Product hierarchy no. *				Part no.	SBU	Type / Description	Customer part no.
SBU PG	PGU	Type					
02	007	002	0000002028	See list below	Appliance Inlet 10A 70°	6100-3

New colour of inlet gasket. Old gasket with black colour, new gasket in blue.

6100-3					0118.2299	
creation date	created by	release date	released by	notification no.	revision	page
2015-07-24	hollenpe	2015-08-18	hollenpe		a	1 of 1

Old product appearance	New product appearance

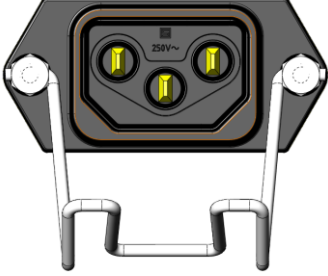
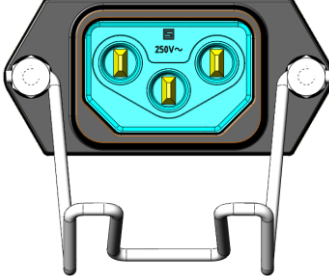
Better visualization of the IP 54 protection of cord connection for 6100-3 with inlet gasket. Safer and easier identification for the end user.
